SERVICE BULLETIN

BT19-014

RATTLE FROM HEAT SHIELD

APPLIED VEHICLES: 2018 – 2019 Armada (Y62)

Figure 3

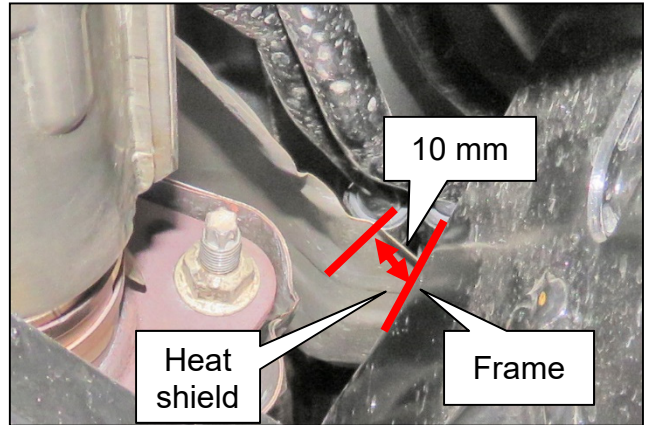
4. Use your hands to adjust the clearance between the heat shield and the top side of the frame to 10 mm.

Figure 4

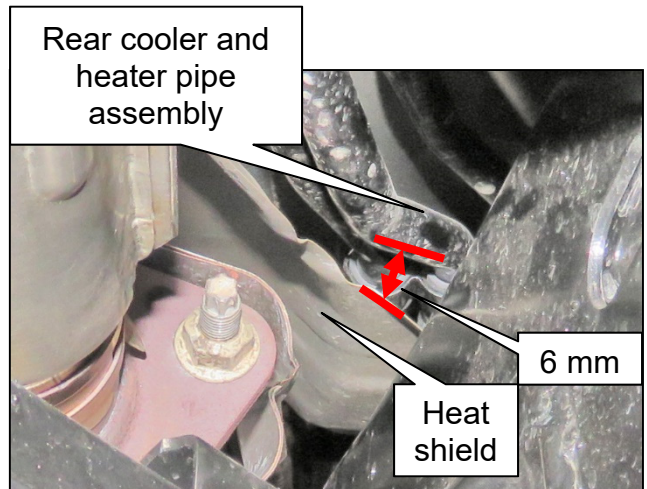
5. Use your hands to adjust the clearance between the rear cooler and heater pipe assembly and the heat shield to 6 mm.
